SITE: Building and curtilage of Greenacres bungalow, and Land to the rear of The Knapp and Westmead, The Homend, Ledbury, Herefordshire

DESCRIPTION: Proposed demolition of existing buildings on site and erection of Retirement Living apartments with associated access, car parking, landscaping, ancillary facilities, and associated works.

APPLICATION NO: 223248

Figure 1: Environment Agency Flood Map for Planning (Rivers and Sea), June 2022

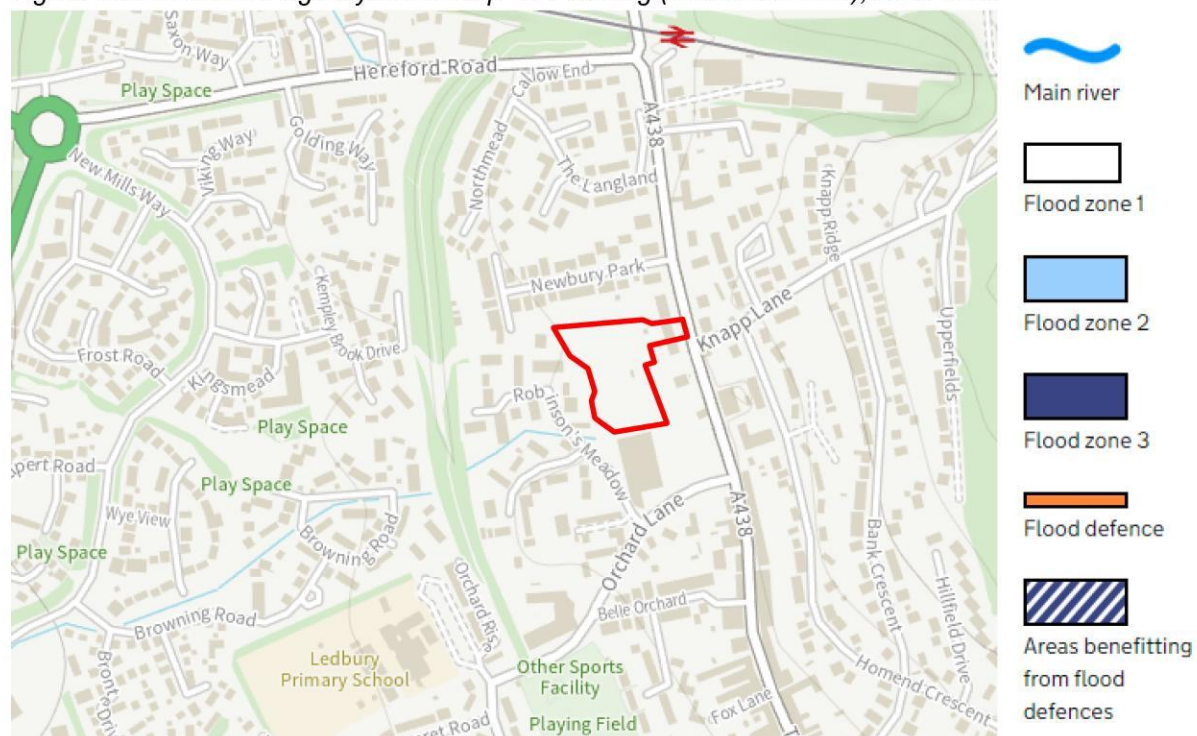
Review of the Environment Agency's Flood Map for Planning (Figure 1) indicates that the site is located within the low probability Flood Zone 1.
